**Re: Proposed ATC / Certificate of Conformity (Significant Mod)
District Facility # S-37
Project # 1133043**

San Joaquin Valley Air Pollution Control District
Authority to Construct
Application Review
4.6 MW Cogeneration System

Facility Name: Kern Oil & Refining Co. Date: 9/24/13
Mailing Address: 7724 E Panama Lane Engineer: R Edgehill
Bakersfield, CA 93307 Lead Engineer: A Phillips
Contact Person: Melinda Hicks and Joe Selgrath – EnviroTech Consultants, Inc.
Telephone: 661-845-0761 (MH) 661-377-0073 x12 (JS)
Application #(s): S-37-151-0
Project #: 1133043
Deemed Complete: August 5, 2013

From: Kyle Melching
Sent: Wednesday, July 31, 2013 2:23 PM
To: Steven Roeder
Subject: FW: Attached Image

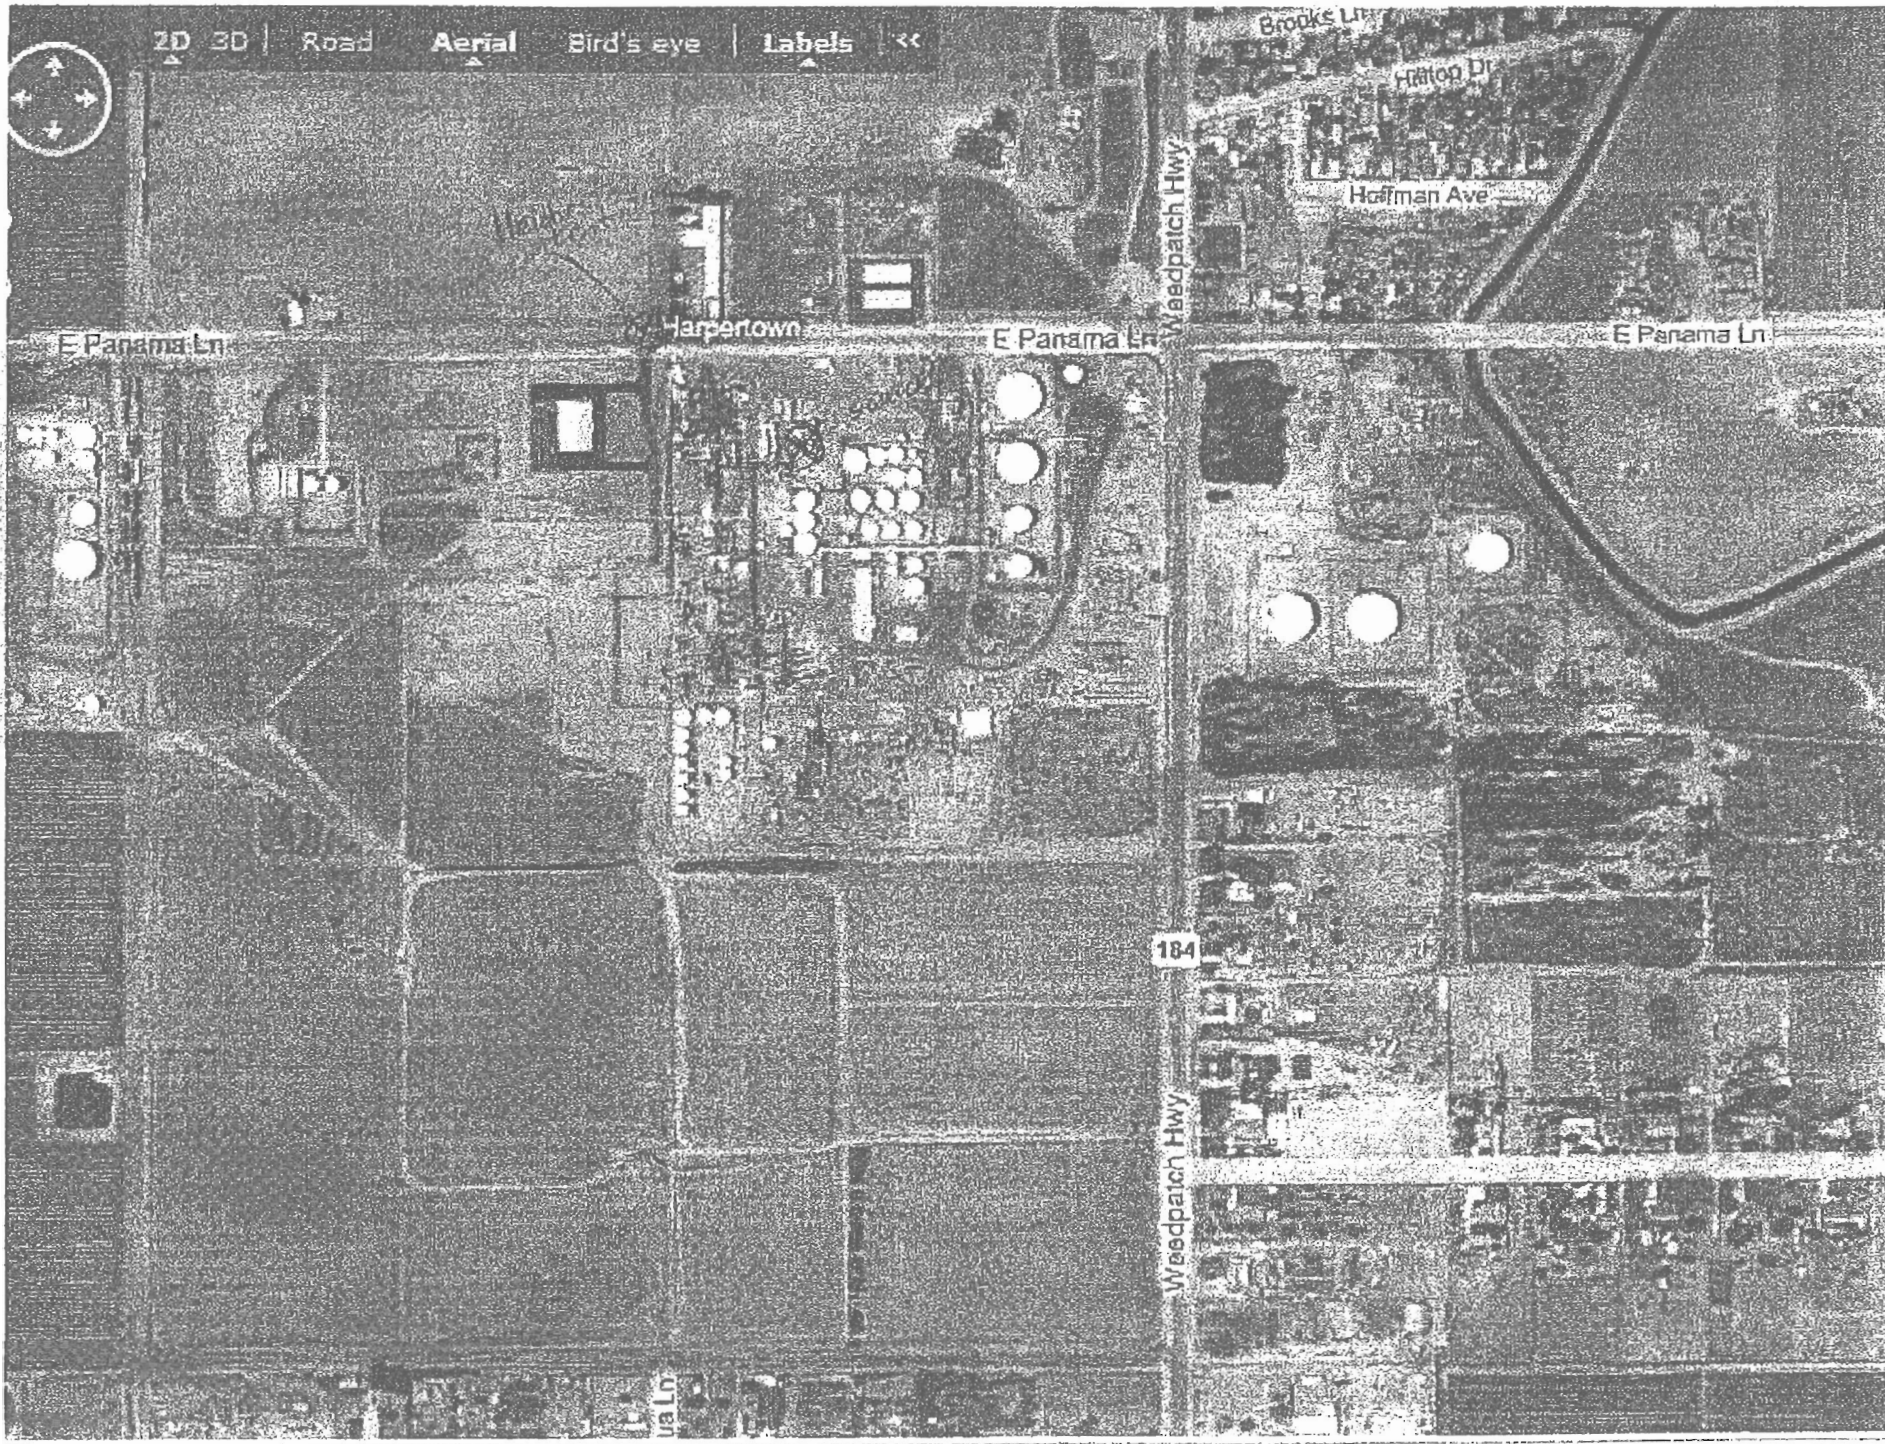
So, the Hourly PM2.5 is not passing. To pass we need a number below 1.2. Currently we are at 3.22. I see that stack height is already pretty high, but the velocity is low. Is 18 ft/sec correct? Also, I've attached a picture of the facilities boundaries that we've used to model an AAQA before and was curious if this is still correct? Not sure if the facility had purchased any extra land that would extend the distance to the boundaries for this source.
